## Submissions Report

**State Significant Development (SSD-73365208)**

Fairfield Showground Community and Events Centre

430-482 Smithfield Road, Prairiewood (Fairfield Showground)

Figure 2 Location of New Pick-Up and Drop-Off Facility

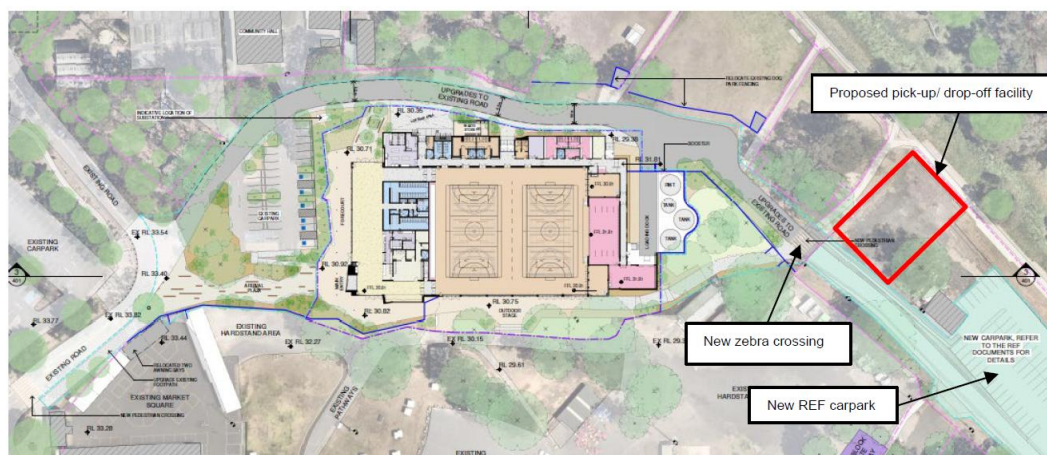
3.5	DPHI has requested a parking strategy that considers parking demand when multiple facilities in the showground are in use.	As above.	As above.
3.6	DPHI has asked for details of drop-off and pickup arrangements.	New drop-off and pick-up arrangements are proposed as described in <b>Section 3.1.3</b> and <b>Attachment H</b> .	<b>Section 3.1.3</b> <b>Attachment H</b>

A new pick-up and drop-off facility has been designated to the north of Fairfield Showground Community and Events Centre with a capacity of 190 to 215 vehicles per hour. The pick-up/drop-off area is to serve the Fairfield Showground as a whole and will be delivered under a separate planning pathway.

Figure 3 Location of Parking Areas CP-2 and CP-3

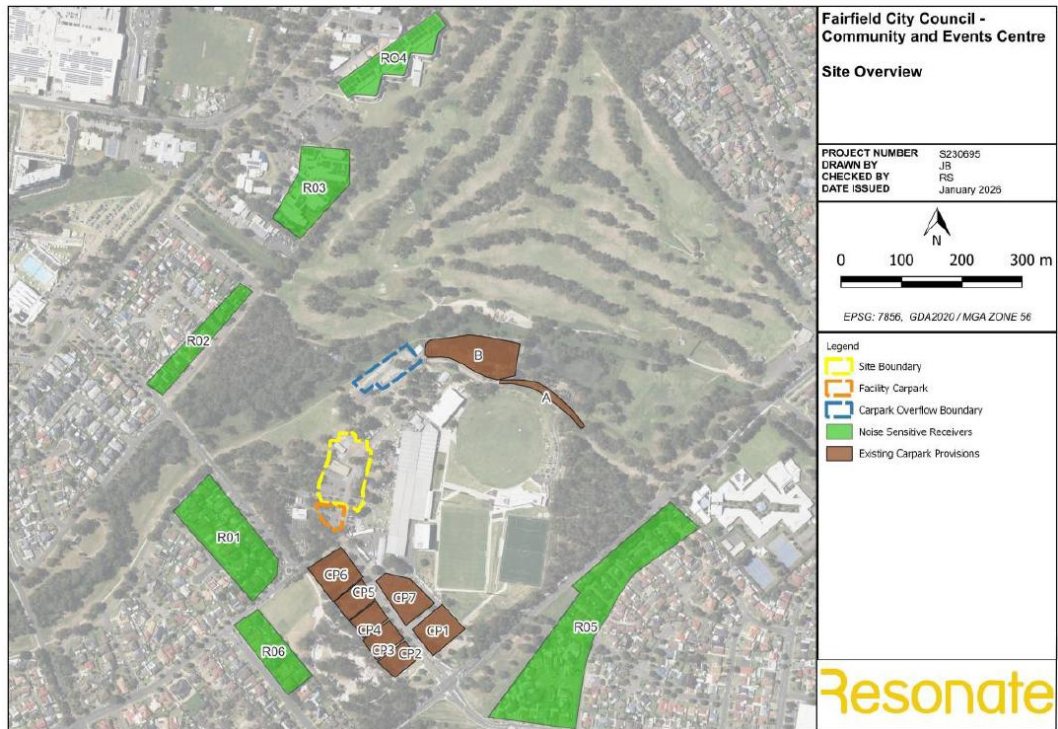
4.4	DPHI has noted the NVIA only assesses carpark noise from two parking areas and requests the assessment is updated to consider noise with all showground carparks in use.	A detailed noise assessment of all carparks is provided as described above in <b>Section 3.1.4</b> and as detailed in <b>Attachment J</b> .	<b>Section 3.1.4</b> <b>Attachment J</b>

The modelling determined that two car parking areas (CP-2 and CP-3) would need to be closed during the operation of the Fairfield Showground Community and Events Centre in order to achieve noise levels below the sleep disturbance criteria for properties nearby on Moonlight Road. The noise modelling demonstrating acceptable noise emissions with CP-2 and CP-3 not operating is shown in **Table 4**.

An amended mitigation measure is proposed as a result of this additional acoustic modelling to ensure CP-2 and CP-3 are not in operation in the nighttime period during the operation of

The closure of CP-2 and CP-3 is practical as it can be easily separated from the rest of the car parking areas and is the furthest on-site parking areas from the Fairfield Showground Community and Events Centre located in the southern-most corner of the site (**Figure 3**).
